Observation on a Strategic Infrastructure Development Application

Lemanaghan Wind Farm

Planning Observation – Lemanaghan Wind Farm Application

Proposed 220kV GIS Substation and Associated Grid Infrastructure

DRAWING TITLE:
Grid Infrastructure Overall Arrangement

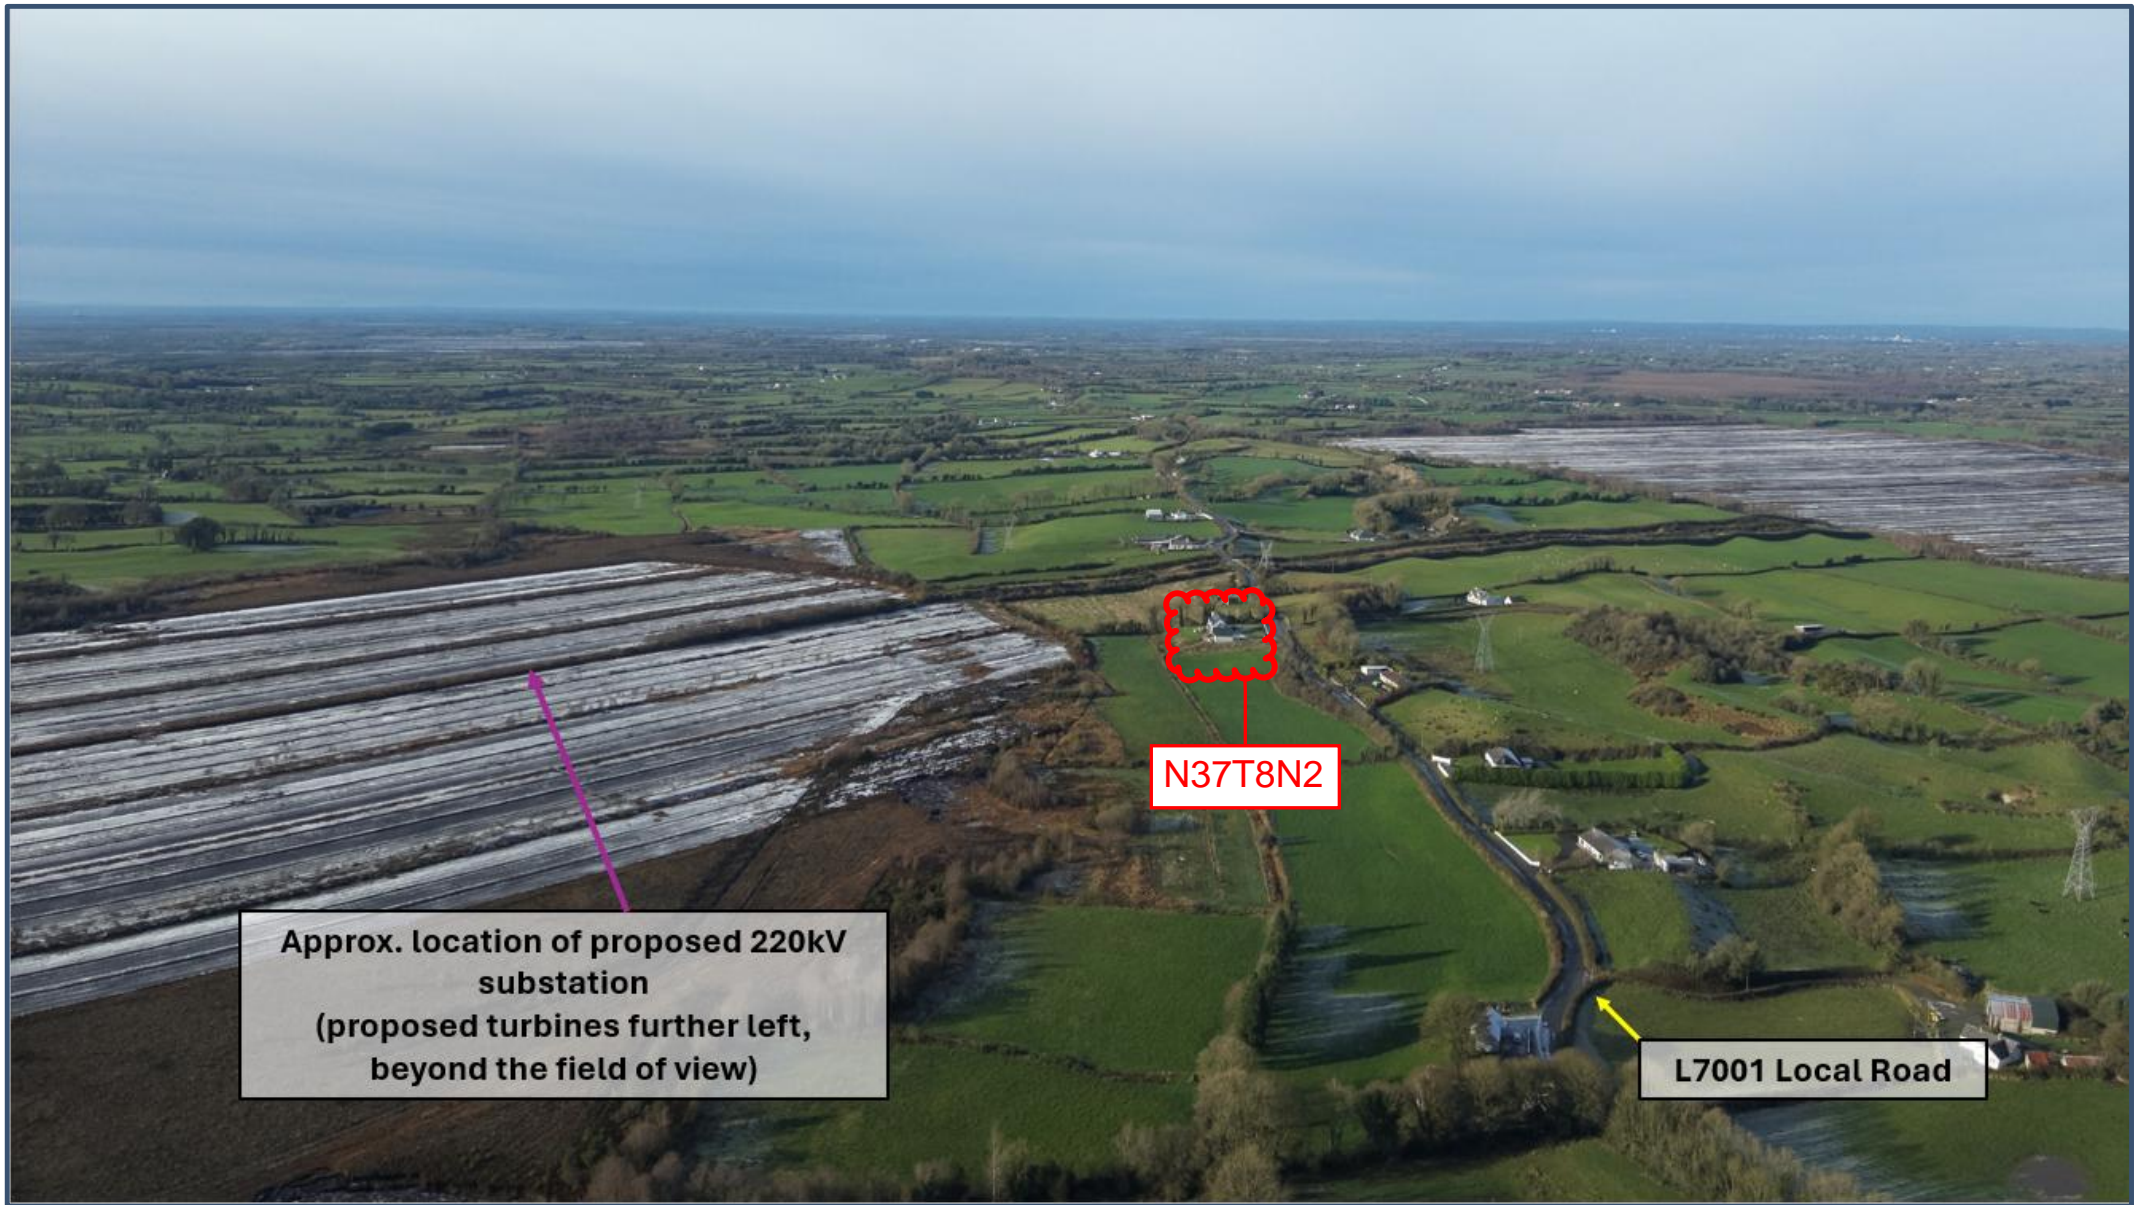
My dwelling is located approximately 350m north of the proposed onsite substation (Appendix A). Drawing *200804_-_37_GIS_Building_Roof_Plan_and_Elevations* shows the finished floor level for the main switchgear building (GIS building) within the substation at 56.90m OD and an overall height and elevation of approximately 21.61m and 78.51m OD respectively. My dwelling sits at an elevation of approximately 62.75m OD and roof level of approximately 70.68m OD.

While the substation site itself sits at a lower ground elevation, the proposed GIS building roof level would rise approximately 7.83m above the roof level of my dwelling and would form a visually prominent industrial structure within close proximity to an established residential receptor (Appendix B).

Figure 14-4

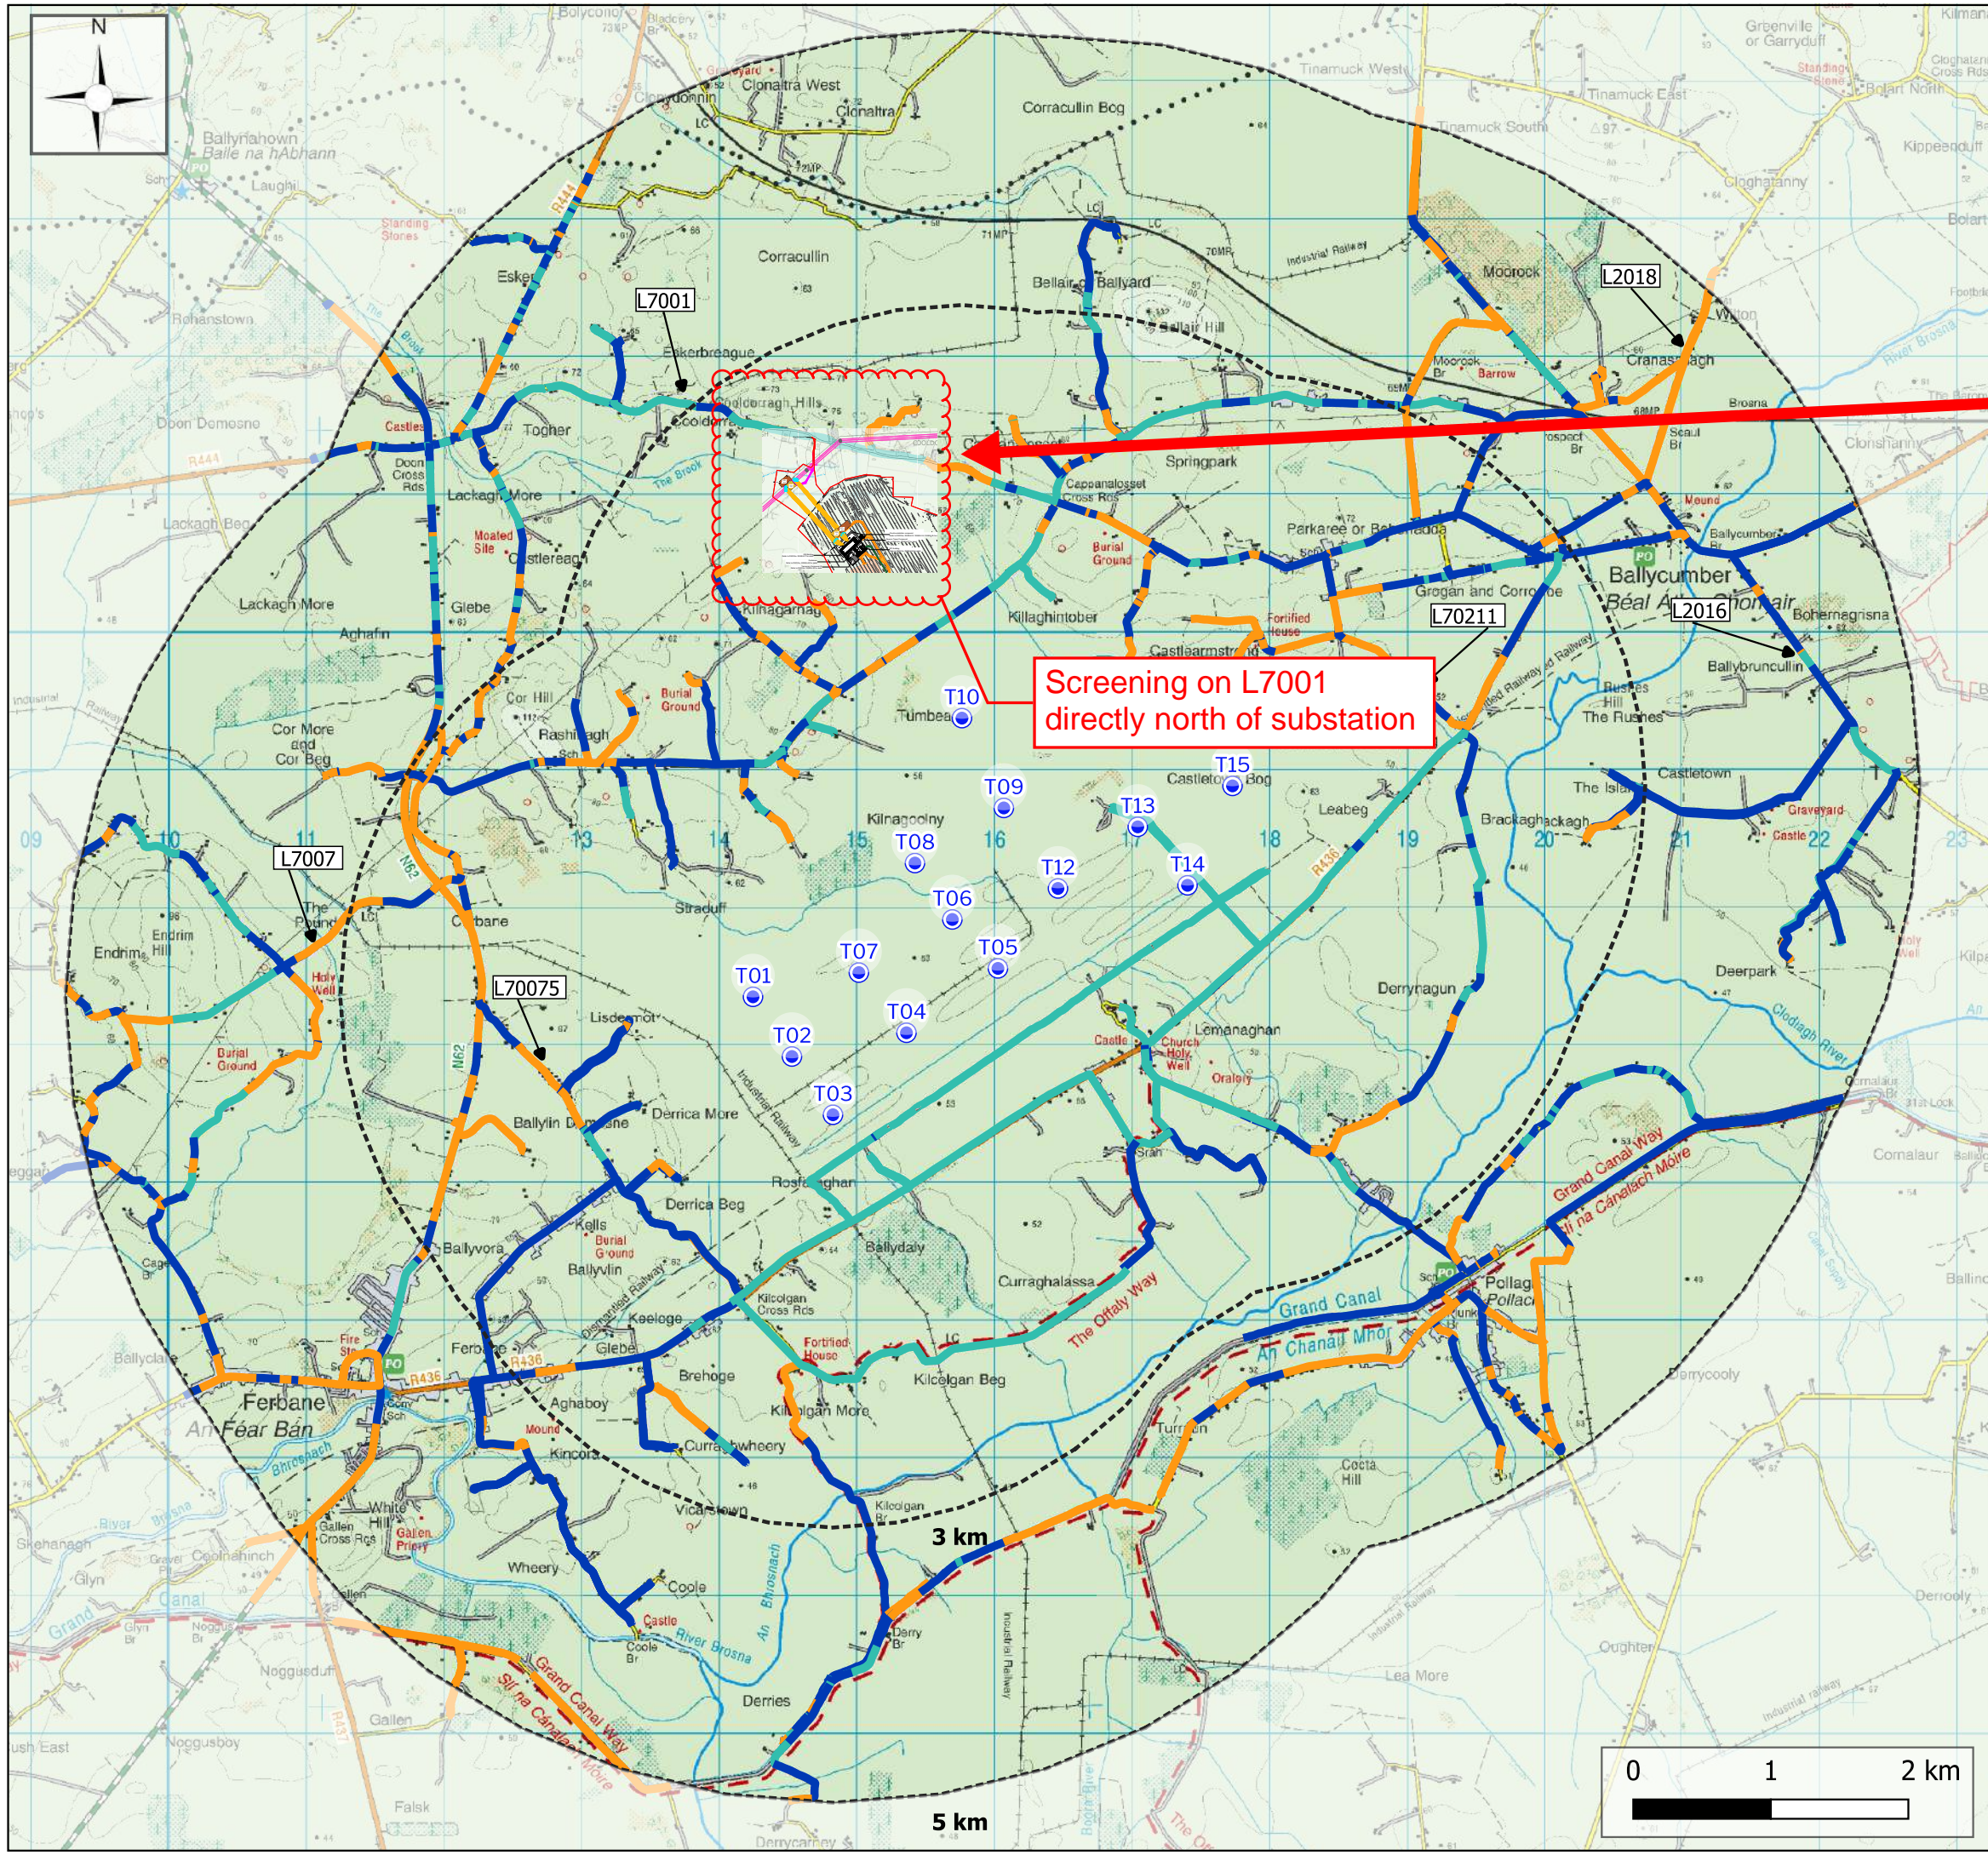
The Route Screening Analysis within the EIAR identifies sections of the L7001 directly adjoining the proposed substation and nearby residential receptors as “Class 1 – No / Very Little Visual Screening.”

The photographic evidence and annotated drawings submitted with this observation (Appendix C) demonstrate that existing vegetation is either absent, intermittent, immature, or insufficient to materially screen views toward the proposed substation, associated steel structures & telecom tower.

However, elsewhere within the Landscape and Visual chapter, the Route Screening Analysis classifies sections of this same road corridor as “Class 3 – Dense / Full visual screening”, while road sections adjoining the selected substation location and nearby residential receptors are identified as “Class 1 – No / Very Little Visual Screening.”

LOOKING SOUTH FROM N37T8N2

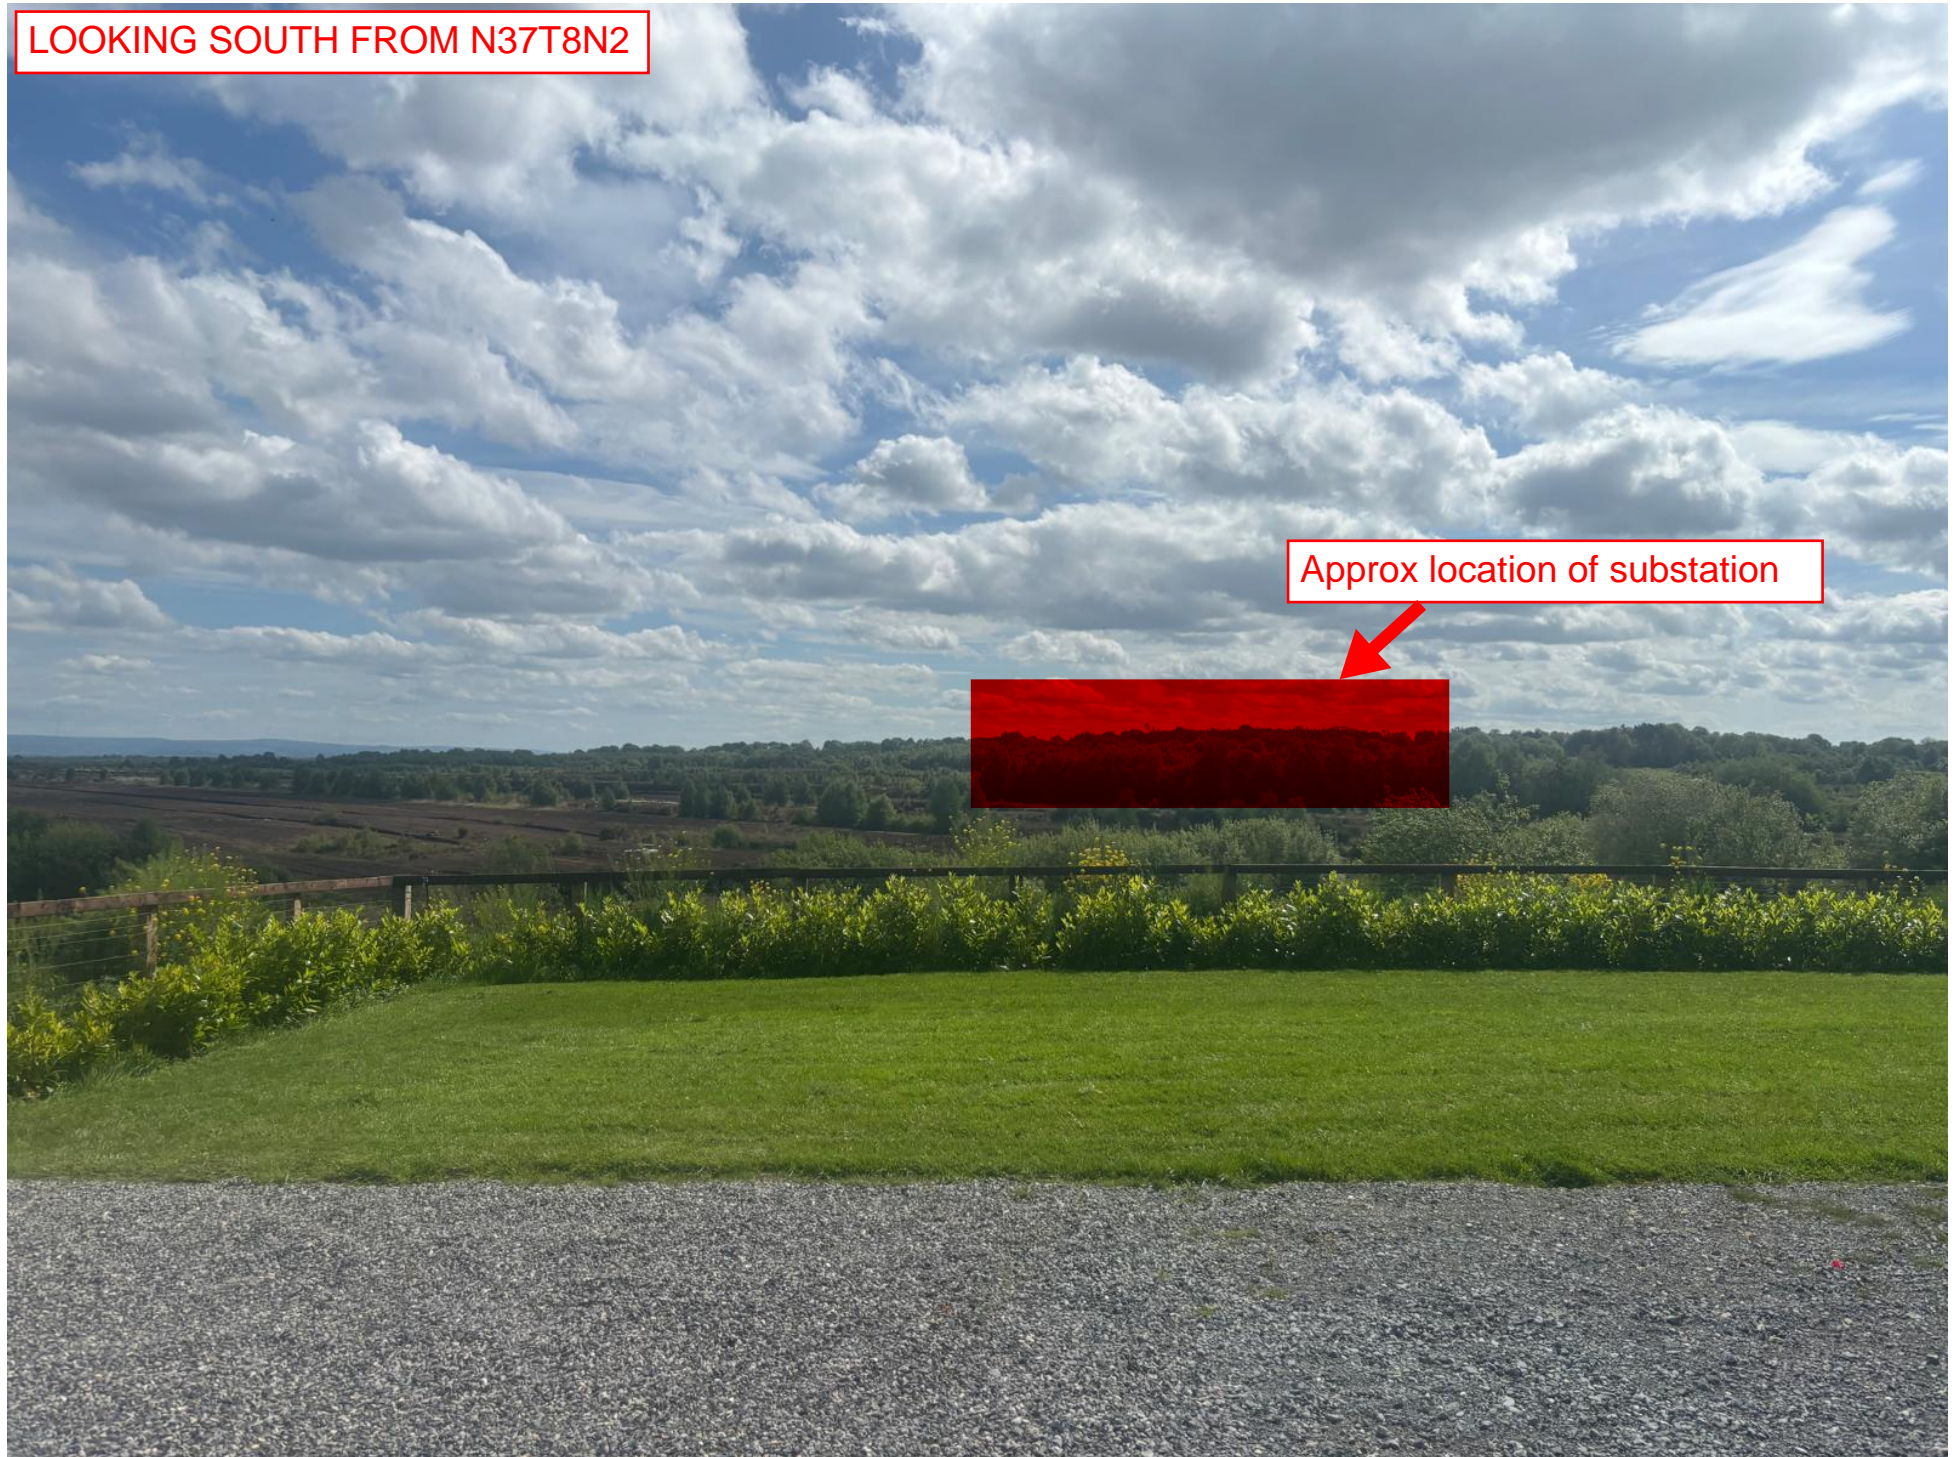
Due to the scale and elevation of the proposed GIS building, the structure would also break the existing horizon line when viewed from nearby residential receptors and sections of the surrounding landscape, introducing visually prominent industrial built form into views currently characterised by open peatland landscapes and distant views toward the townlands of Kilnagarna, Thumbeagh and Rashinagh.
